AM57xx Linux System Timer

RE: System Timer issue on AM57x for Nari

Diagram: Figure 4-1 from AM572x Sitara Technical Reference Manual (SPRUHZ6K)

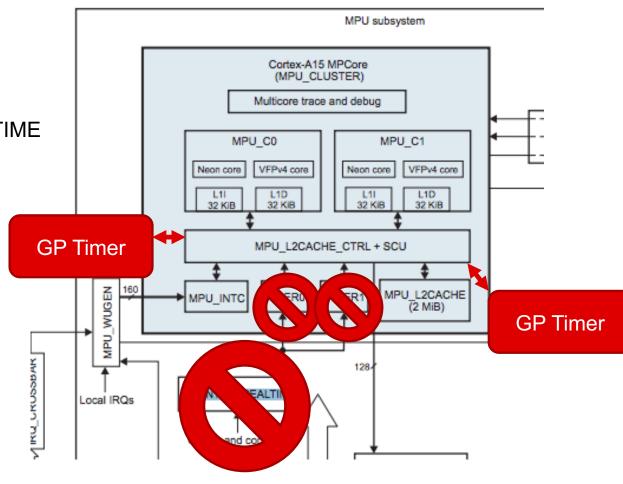
COUNTER_REALTIME
Saturates (reaches 0xBB8000000000)
at 40 bits and stops incrementing Linux
System Timer

- When Linux system time stops, effectively all scheduling stops except for interrupt driven or command/response
 - Linux thinks time has stopped

Arch timers fed by COUNTER_REALTIME are no longer used

GP Timers are used instead, one for each MPU core

Another is used for System Time

- Patchset provided to switch Processor SDK 2.00.02.11 from current Arch timers to use 4 GP Timers
 - 5 patches provided to disable ARCH timer and add support for GP Timers for time keeping
 - Patches may need porting to a specific HW platform
 - Tested on an AM572x GP FVM
- This changes the uptime behavior as timers are reloaded when they expire
 - They do not saturate like COUNTER_REALTIME
 - Linux will keep going
